**ADDENDUM NO. 2****DATE:** July 15, 2026**PROJECT:** Ground Storage Tank
Sardis Water Association**BID DATE:** July 28, 2026, 1:00 PM

ITEM #2: Specifications – 221219 – Prestressed Concrete Water Storage Tank

BID SET
GROUND STORAGE TANK
TANK PLAN & ELEVATION

JOB NO.	26004
SHEET NO.	7

B
7

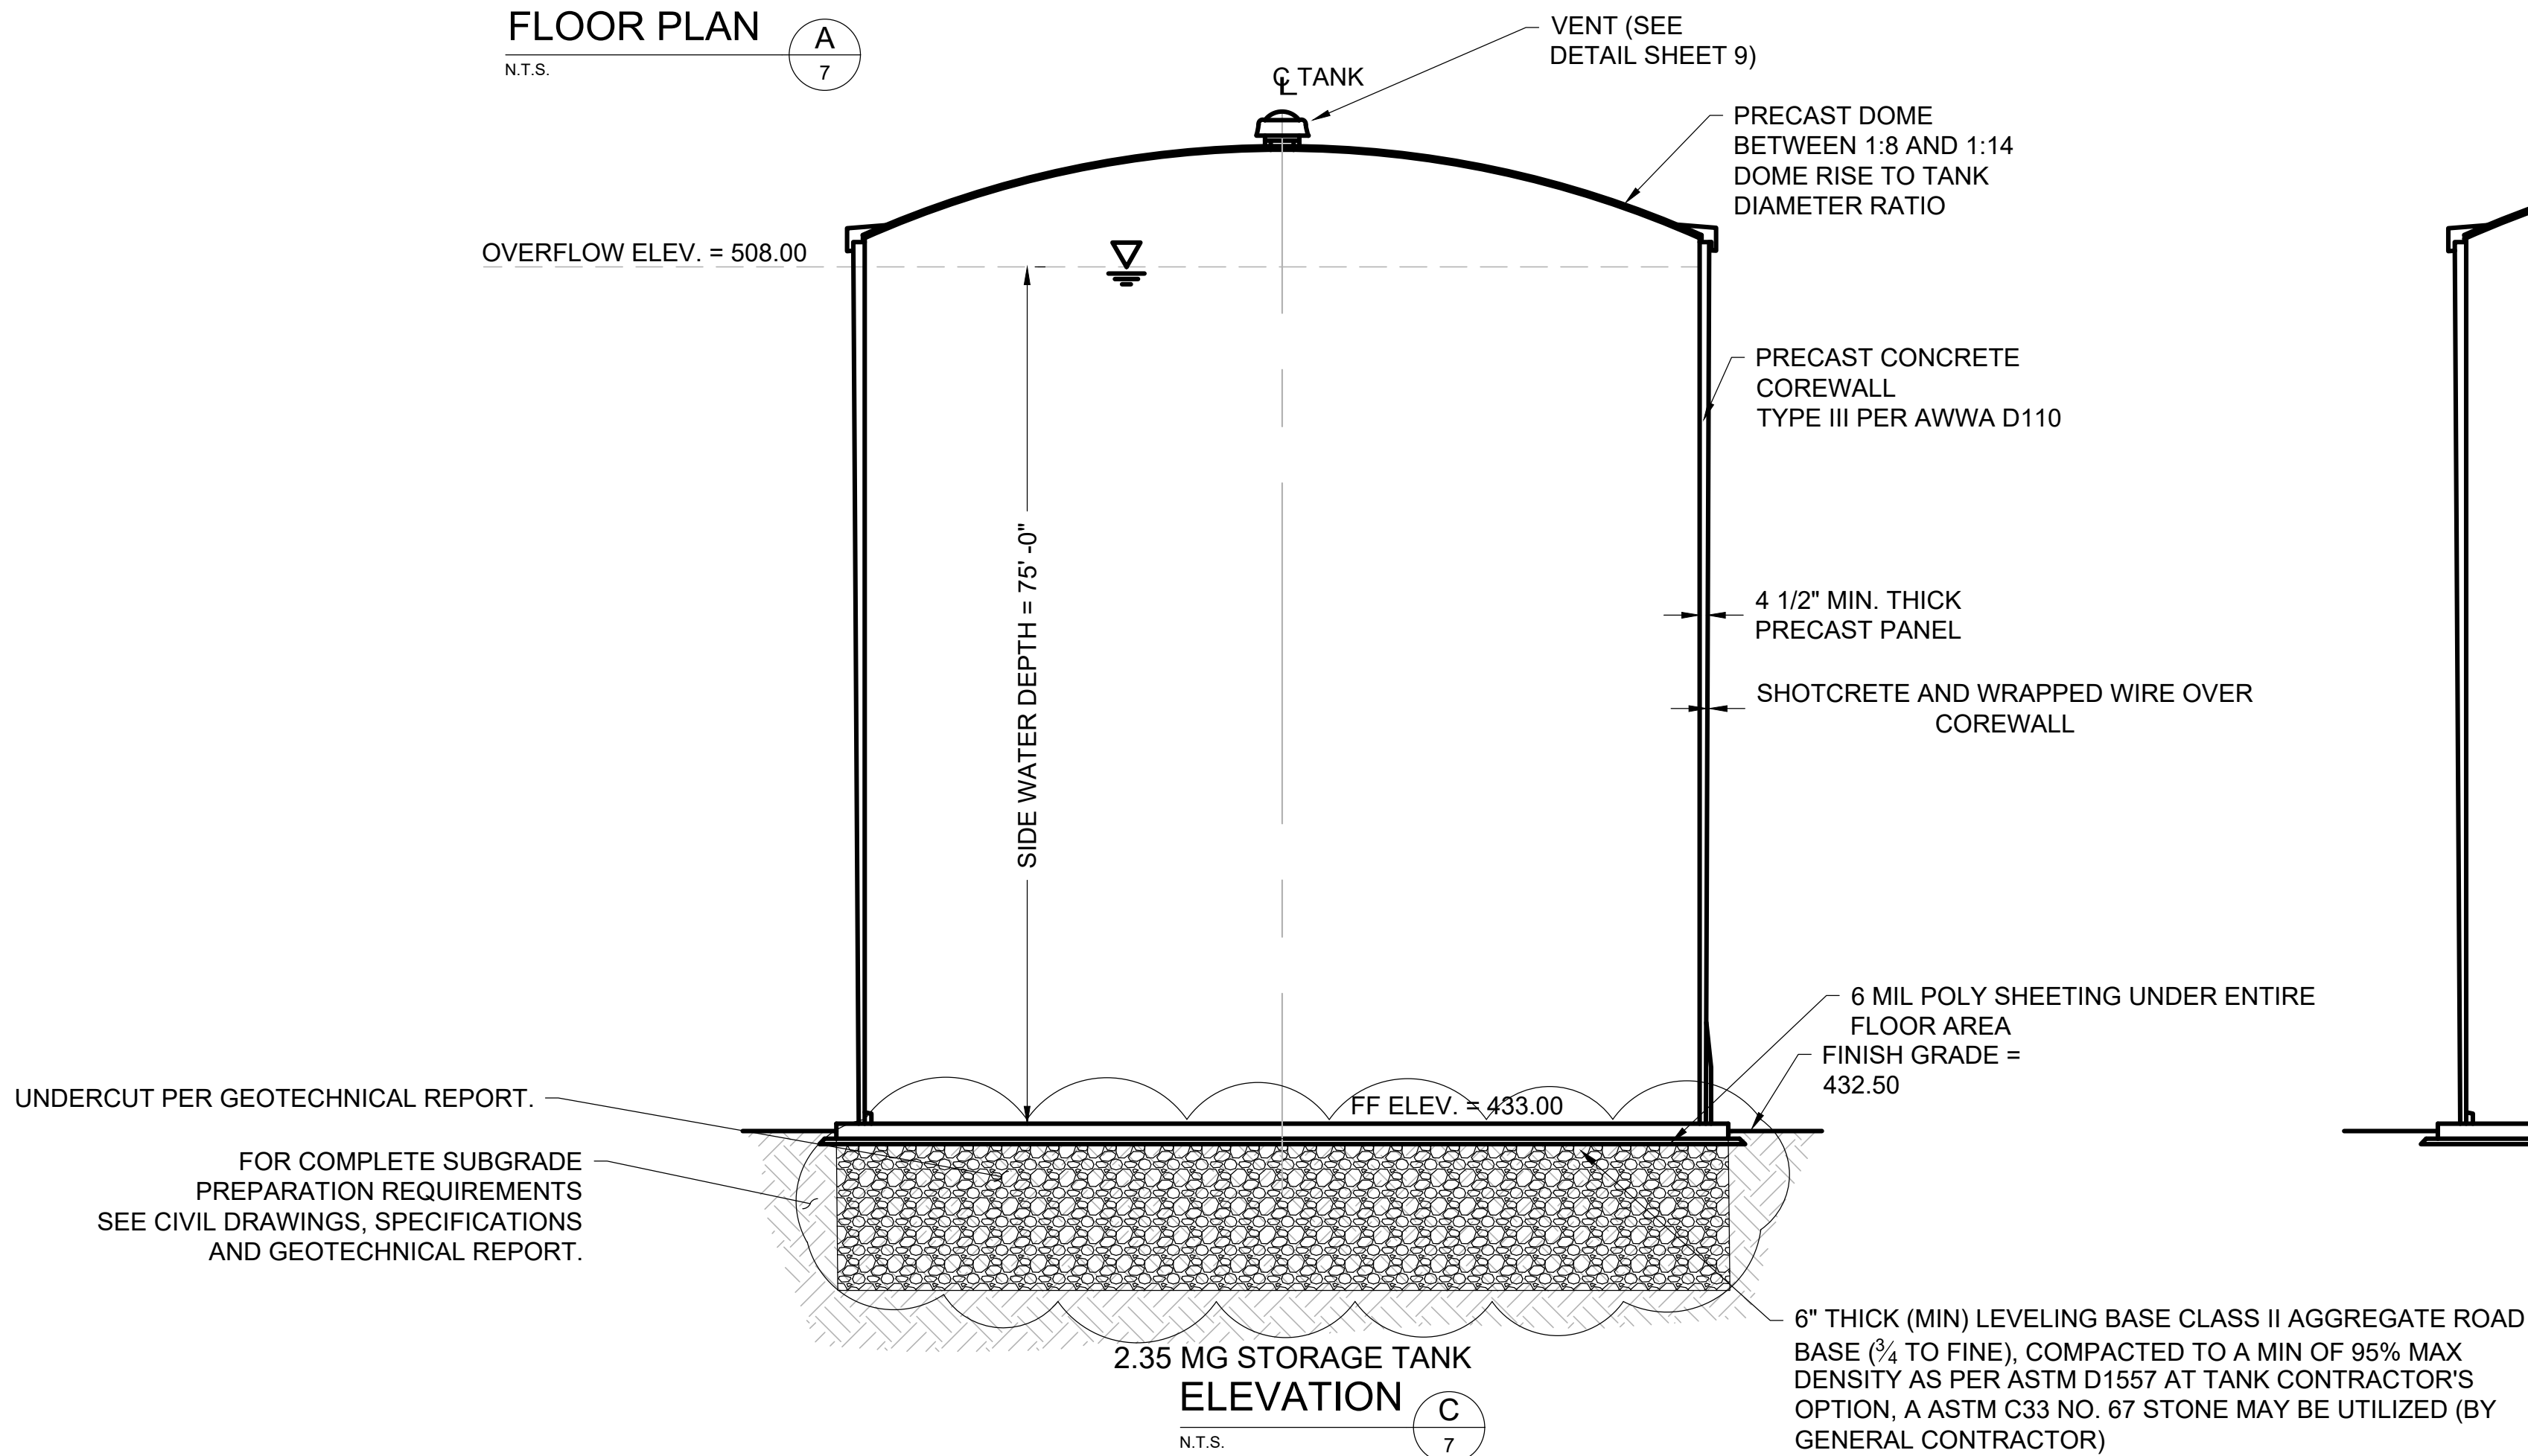
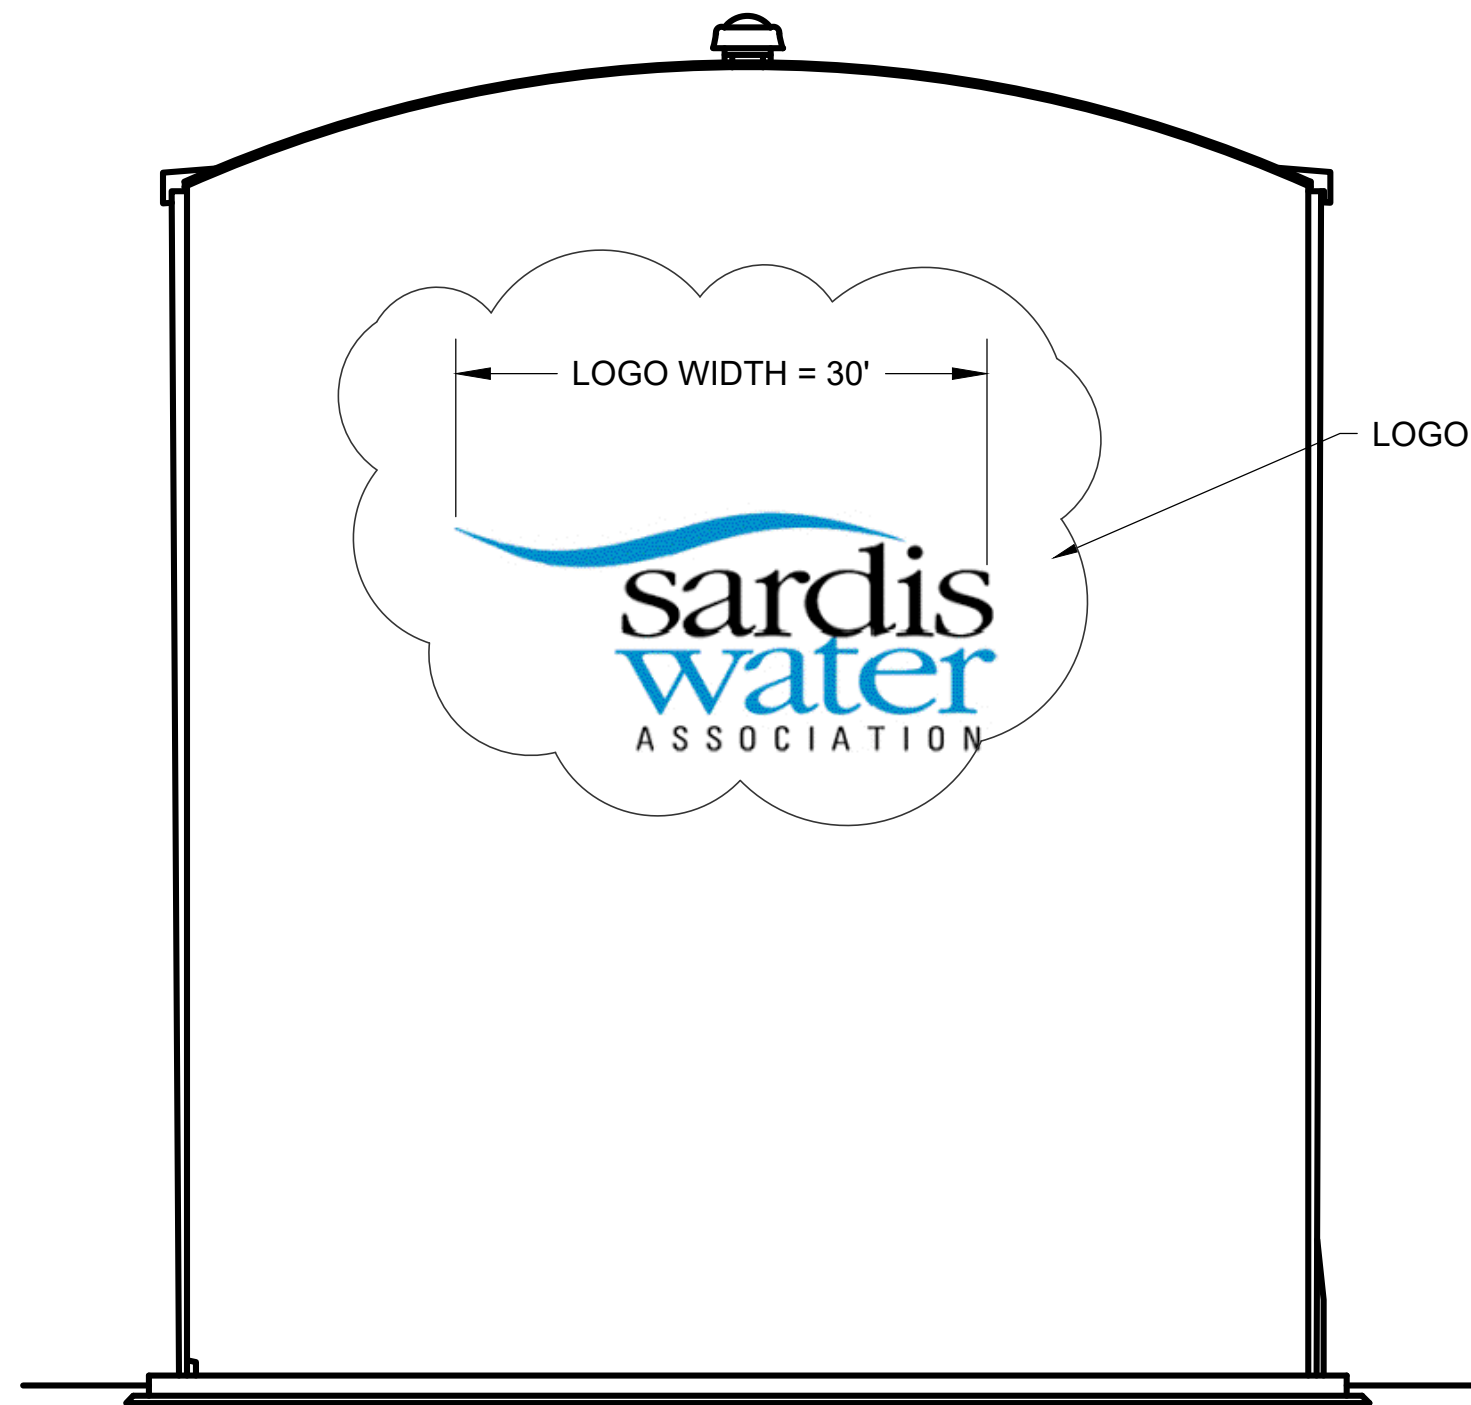
ITEM #5: Drawings – Revised Sheet 7

See revised sheet 7 for the following:

1. Logo Information
2. Undercut requirements per Geotechnical Report
3. Removed 1-foot minimum thickness for tank floor.
4. The rest platform is to be located at the midpoint height of the exterior ladder.
